ECAC WORKING GROUP COMMENTS ON EIS AND HYDROGEOLOGICAL STUDY
for **735 Southdale Road West**

Received at ECAC's March, 2023 meeting

Comments in yellow are based on revised EIS received after March 2024 meeting which has comments from S. Evans, S. Hall and S. Levin.

Small wetland community 3 (SAS)

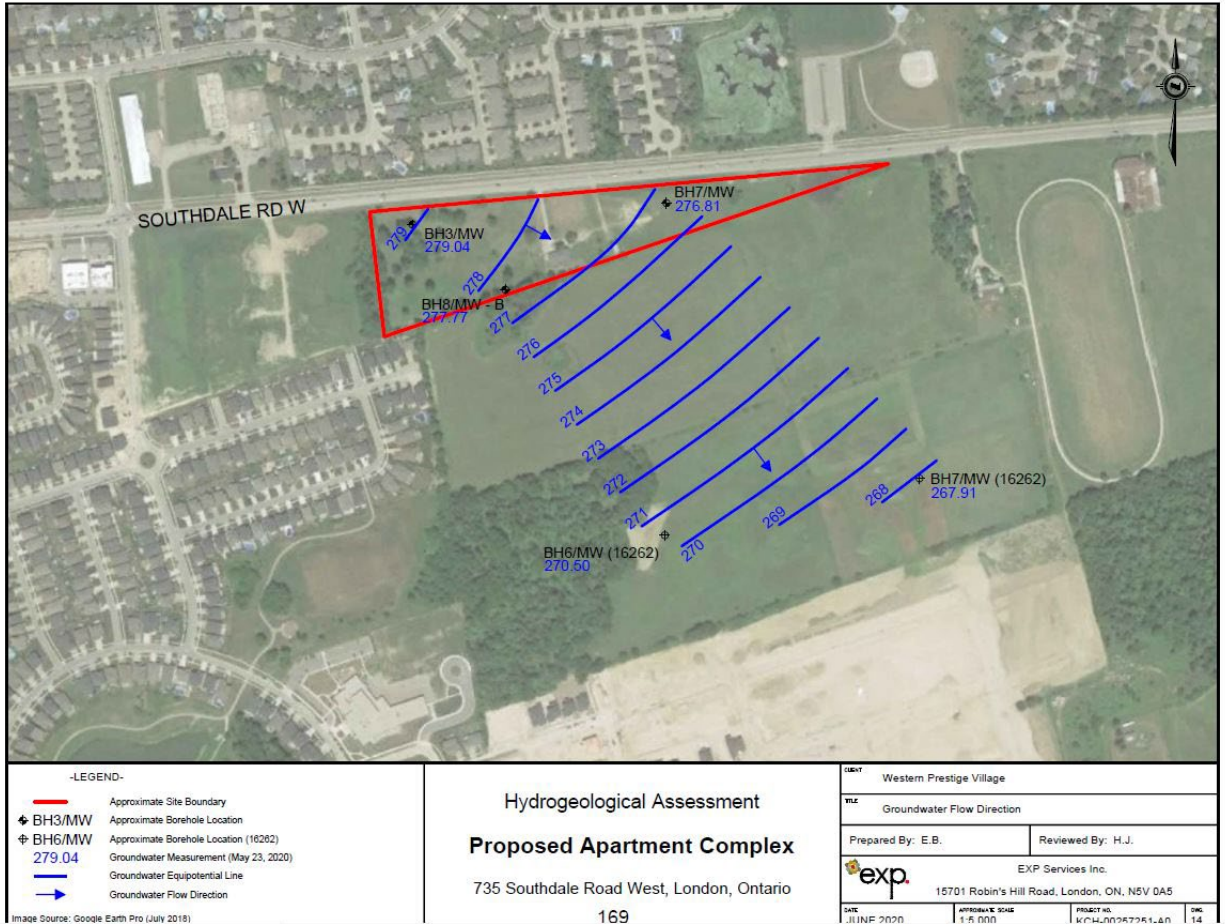
While known it is to be removed and relocated to the property to the South under that plan of subdivision, the statement on page 23 (“It is our opinion that small ponds such as these are not under-represented in London and not biologically important to be considered in this context,” should be considered suspect especially when there is city policy to permit the relocation of small wetlands. Also, the 2006 inventory of Regionally Significant Vegetation Communities done by Bergsma and DeYoung indicated that **SAS made up only 0.21% of ecosites in London.**

ECAC comment on revised EIS: MTE still takes the position that it is not an under-represented site. However, the issue remains the success of the planned relocation and the type of wetland that will be recreated. City staff are working with the proponent on this matter and ECAC has been given to understand that a City Ecologist is involved in this work.
